DUPLEX PUMP  
CONTROL PANEL  
WEST KENTUCKY

# AS BUILTS

JUNE 29, 2010  
FIELD REVISIONS  
DECEMBER 9, 2020

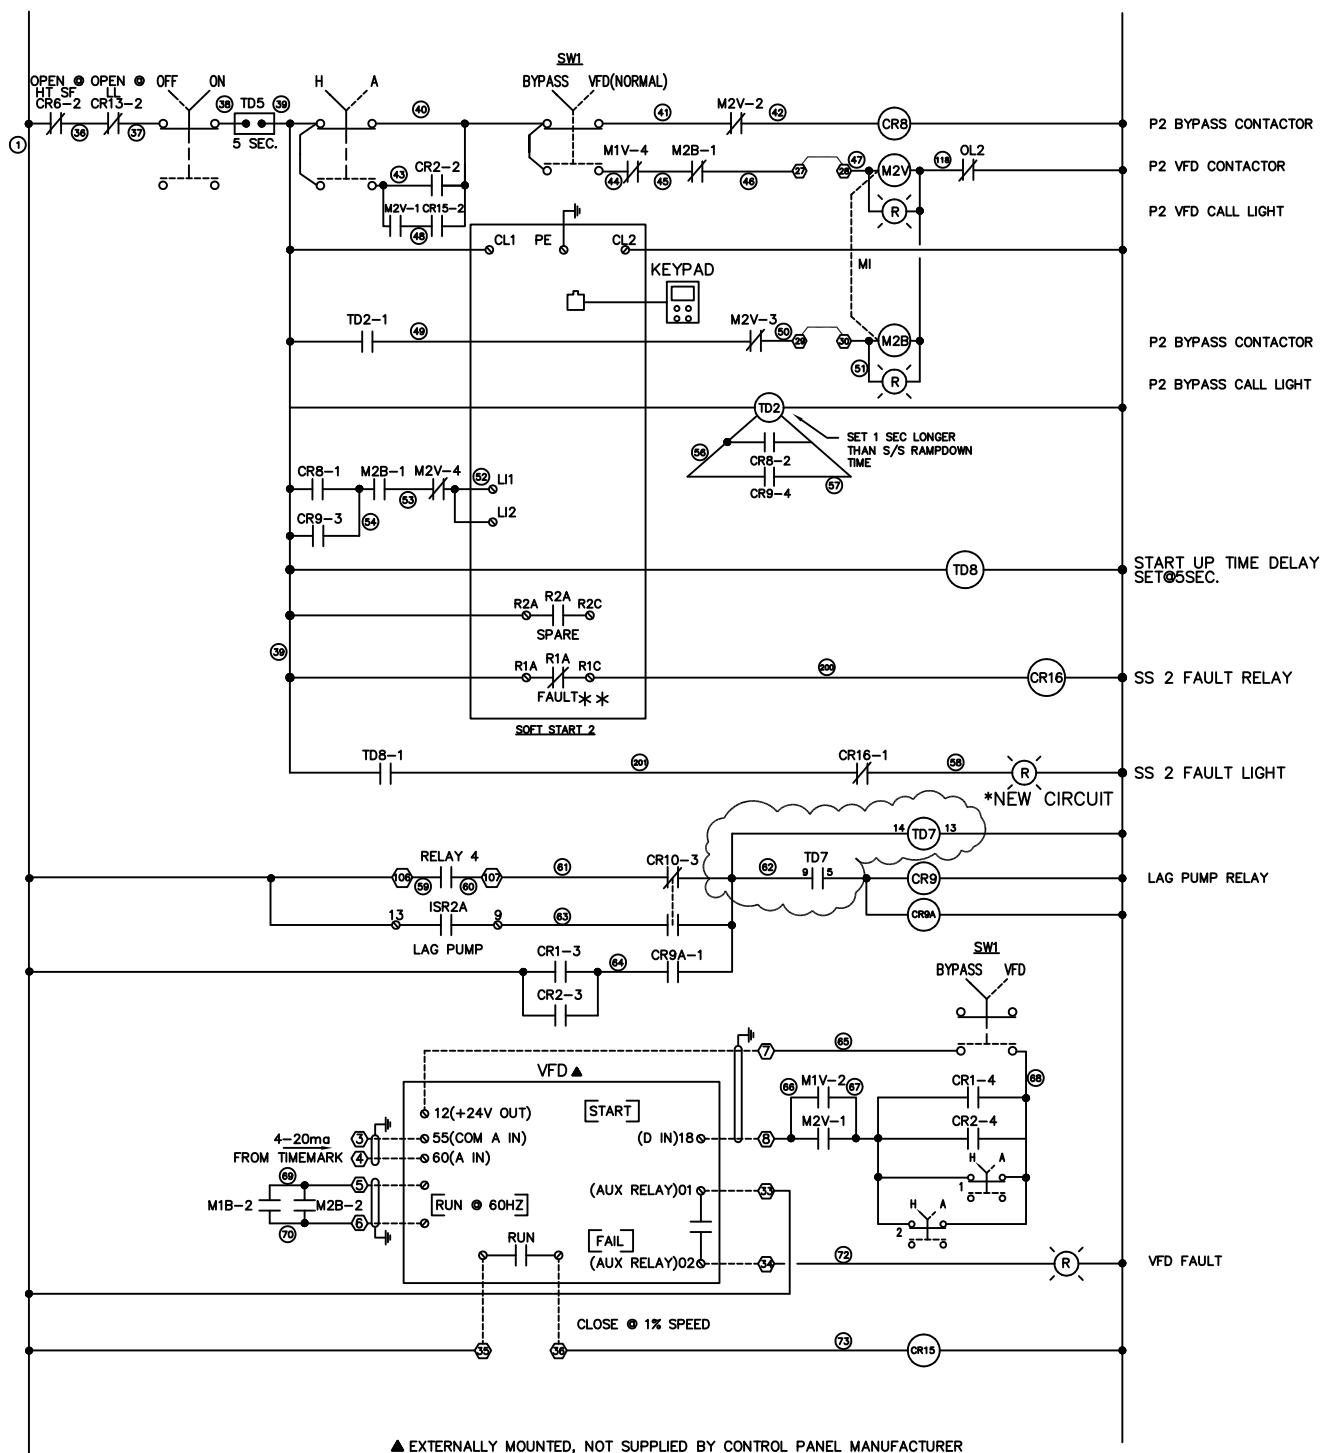
\* REMOVE WIRE #62 FROM CR9 & 9A, MOVE TO TD7 Ø 9, 14  
RUN NEW WIRE FROM TD7 Ø 5 TO CR9, 9A  
RUN NEW WIRE FROM CR9 NEUTRAL TO TD7 Ø 13

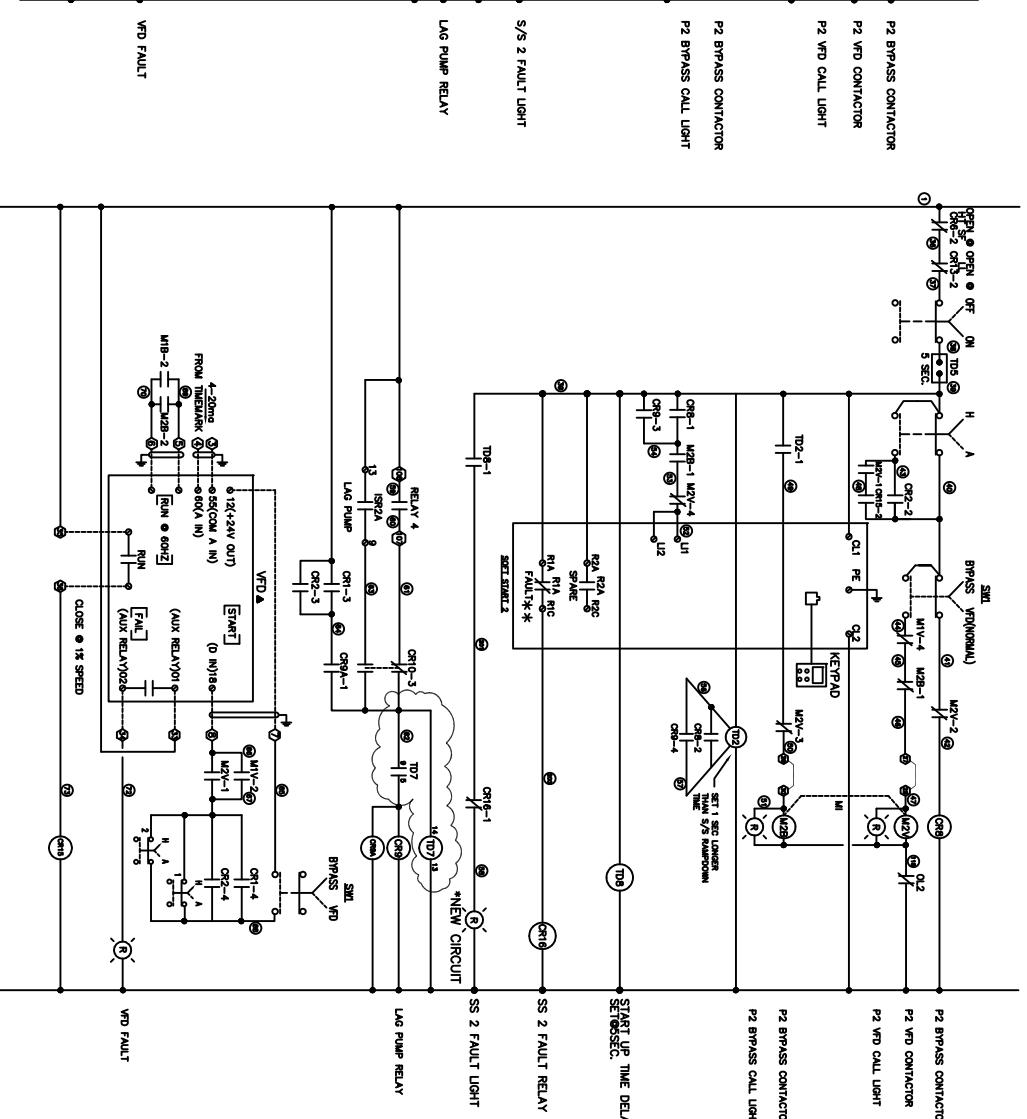
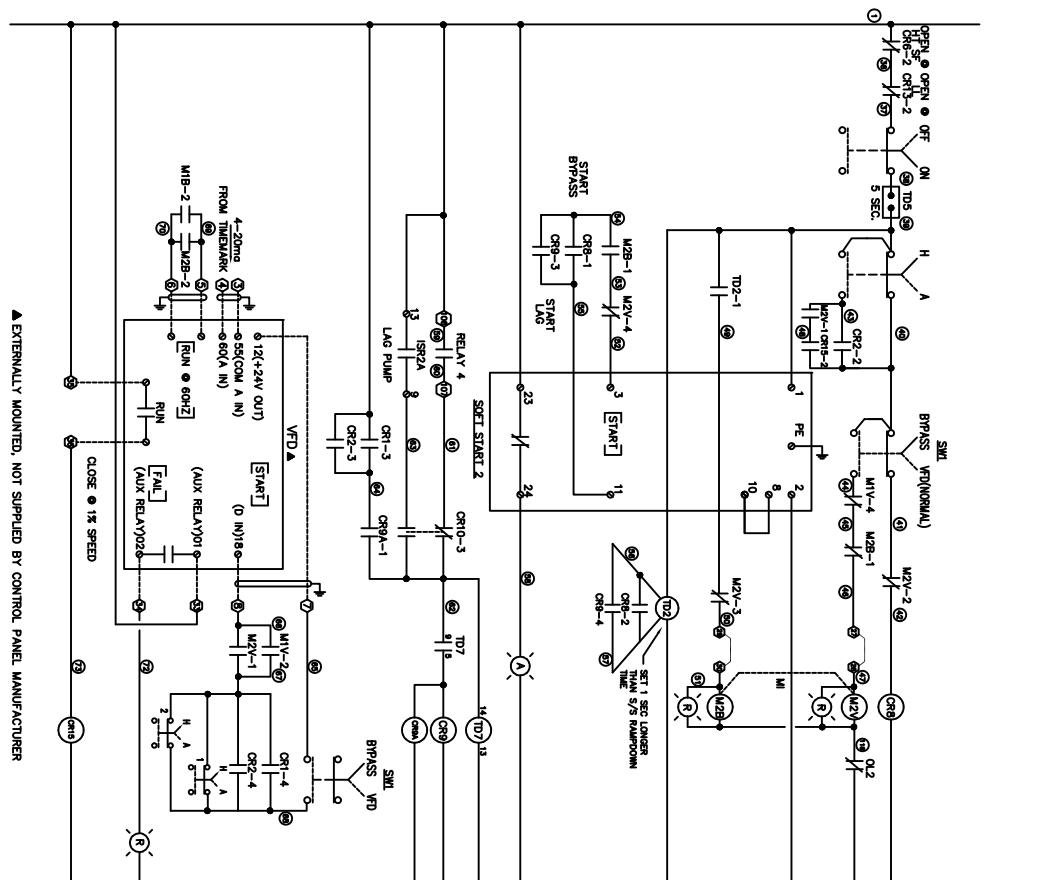
\* REMOVE WIRE #62 FROM CR9 & 9A, MOVE TO TD7 & 9, 14  
RUN NEW WIRE FROM TD7 & 5 TO CR9, 9A  
RUN NEW WIRE FROM CR9 NEUTRAL TO TD7 & 13
